Model: Model S-C2		Date: 25-May-04	No.: RB129001
Subject: When installing the optional paper tray unit (B421)		Prepared by: A. Ishiyama	
From: 1st Tech. Support Sec. Service Support Dept.			
Classification:	<input checked="" type="checkbox"/> Troubleshooting	<input type="checkbox"/> Part information	<input checked="" type="checkbox"/> Action required
	<input type="checkbox"/> Mechanical	<input type="checkbox"/> Electrical	<input type="checkbox"/> Service manual revision
	<input type="checkbox"/> Paper path	<input type="checkbox"/> Transmit/receive	<input type="checkbox"/> Retrofit information
	<input type="checkbox"/> Other ()

Model: Stella-C2		Date: 23-Jul-04	No.: RB129002
Subject: PS3 Option not functioning		Prepared by: M. Ishihara	
From: 1st Tech. Support Sec. Service Support Dept.			
Classification:	<input checked="" type="checkbox"/> Troubleshooting	<input type="checkbox"/> Part information	<input checked="" type="checkbox"/> Action required
	<input type="checkbox"/> Mechanical	<input type="checkbox"/> Electrical	<input type="checkbox"/> Service manual revision
	<input type="checkbox"/> Paper path	<input type="checkbox"/> Transmit/receive	<input type="checkbox"/> Retrofit in

Fixing the Side Fence in Place

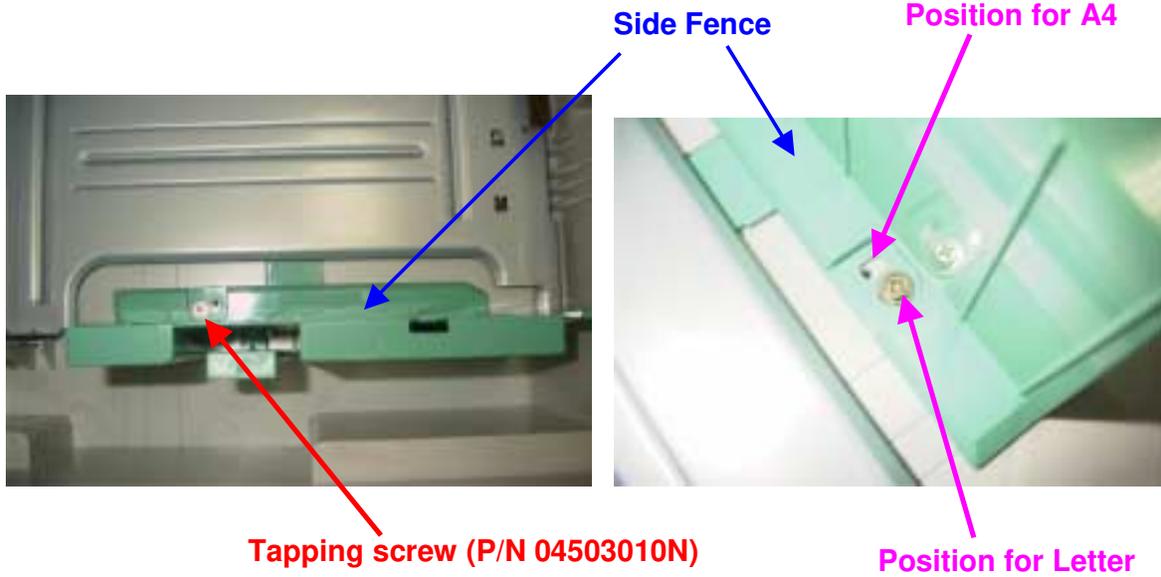
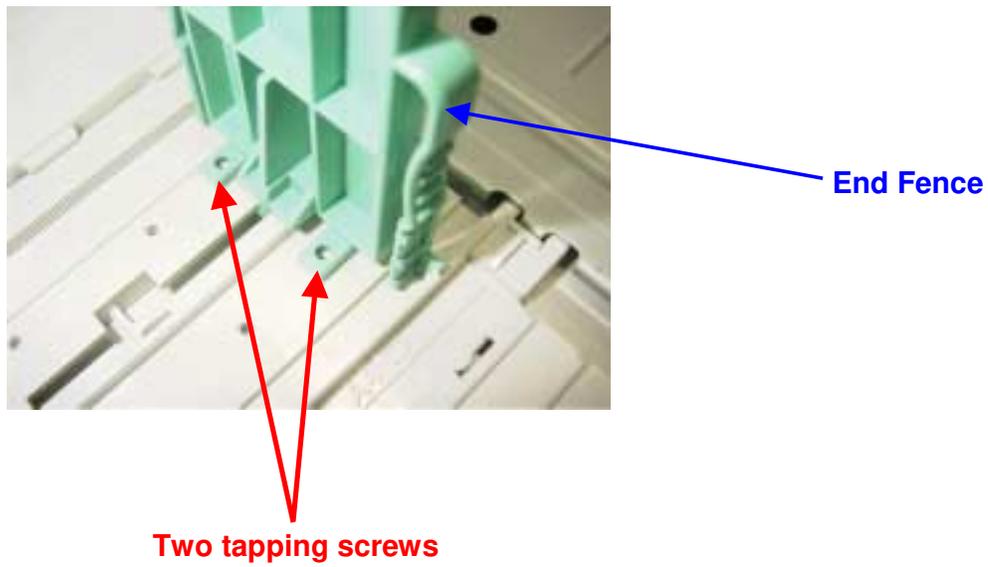
Non-feed jam in the optional paper tray unit.

The side fence can shift inward when the operator loads the paper incorrectly (e.g. not fanning the stack, not placing it in the tray gently), which can then tighten the fence's hold on the paper and make it difficult to feed.

A tapping screw (P/N 04503010N) will be packed together with the optional paper tray unit (B421) for securing the side fence in place at installation.
Applied from: June 2004 unit production.

After gaining the consent of the customer, please fix the side fence to the base of the cassette using one tapping screw.
(See the photos on the next page).

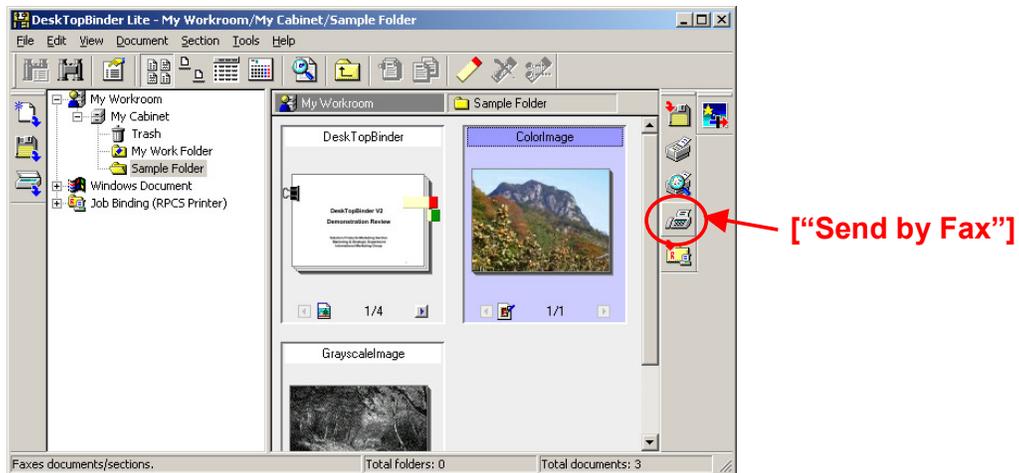
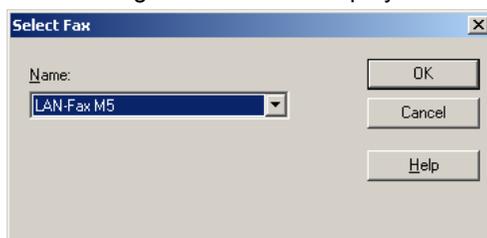
The M5 LAN-Fax Driver is not displayed when it is used as a fax driver within a third-party application. Instead, an error message is displayed (see below).

If “Send by Fax” is clicked, this error dialog is displayed:

Firmware modification.

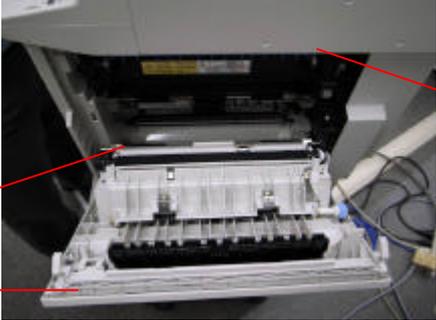
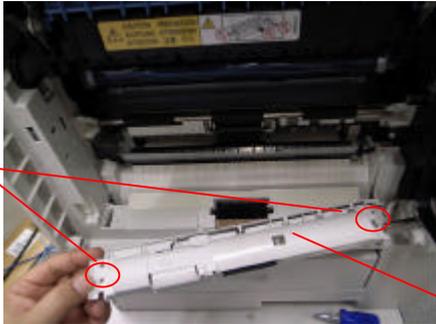
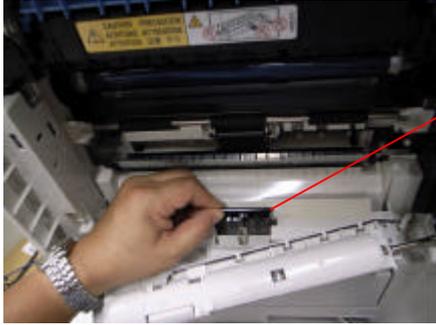
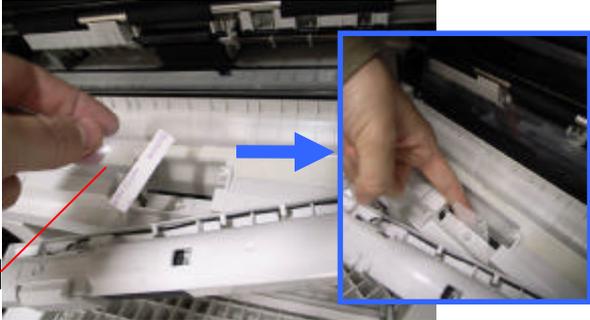
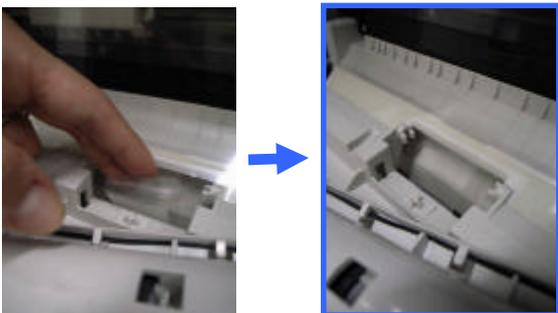
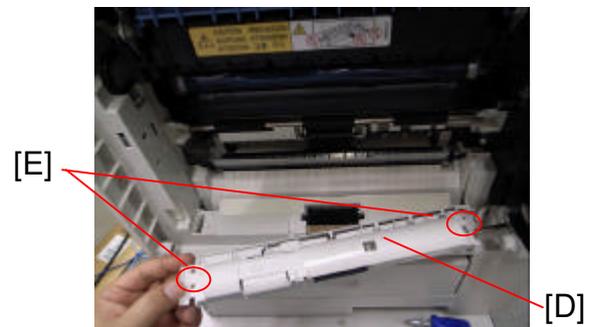
Attach "Anti-jam Mylar" sheet [A]. (See "Procedure" on P.3/4 and P.4/4)

<p>1) Open and remove the right door [A] of the machine (1 belt [B] & 1 connector [C]).</p>	
<p>2) Partially remove the "Guide Plate - Manual Feed" [D]. Using a short Phillips screwdriver, remove the two screws [E]. Note: The left side will swing clear (see the photo), but the right side is connected and supported by a gear, and with a wire connection as well. It's not necessary to fully remove this.</p>	
<p>3) Remove the Friction Pad (and spring) [F]. To remove the Friction Pad, push down with enough pressure to release it from the clips it snaps into, and then pull it back up through the wide part of the opening.</p>	
<p>4) Attach the Mylar [G]. Remove the paper from the adhesive side of the Mylar, and attach in the center of the opening. Be sure to rub back and forth over the area with the adhesive after attaching the Mylar, to be certain that it is properly attached.</p>	
<p>5) Position the Mylar behind the existing long Mylar strip as shown in the photos.</p>

**B0442711/ B2622711****Bottom View of Cassette**

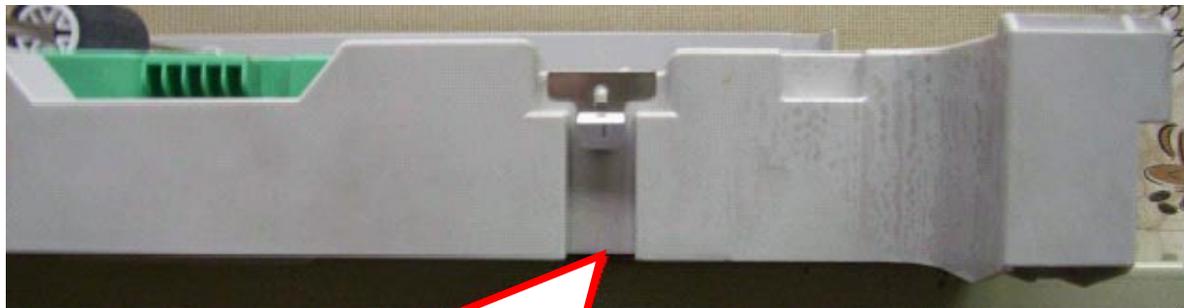
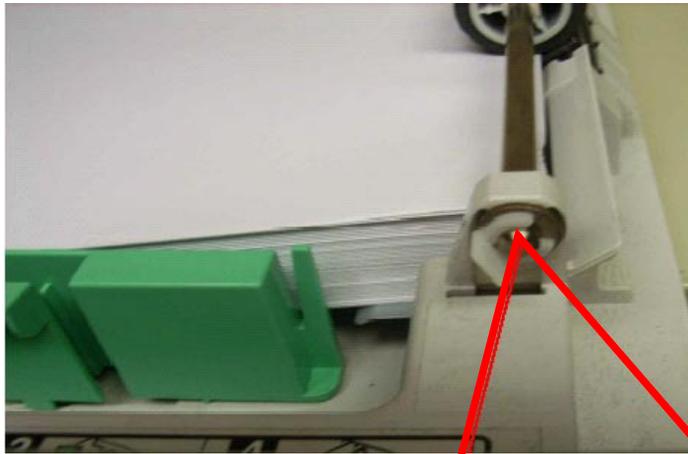
- SC929 occurs
- Paper jams
- Intermittent digital lines appear on copies

One or both grounding plates on the bottom of the main body paper cassette may not be making proper contact. Reform or replace the grounding plates so that they make proper electrical contact.

Make sure to form the grounding plate to the rear so that it makes contact with the bottom machine frame.

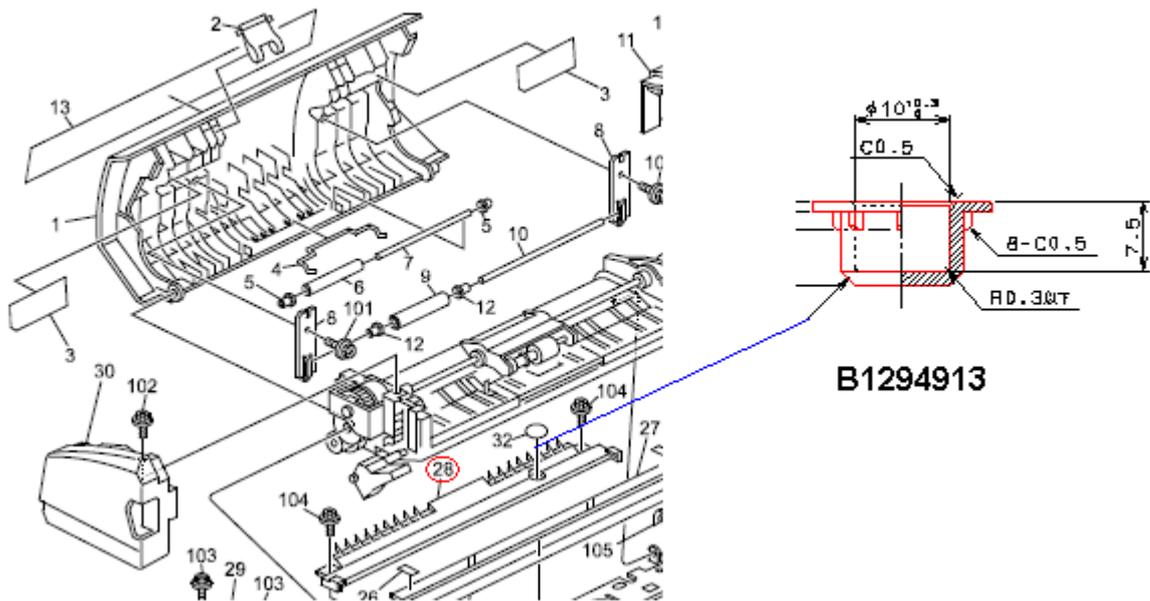
Change: The guide plate has been changed in shape

Reason: To ensure that the S2 sensor on the ADF functions.

(Replace the guide plate with the cap.)
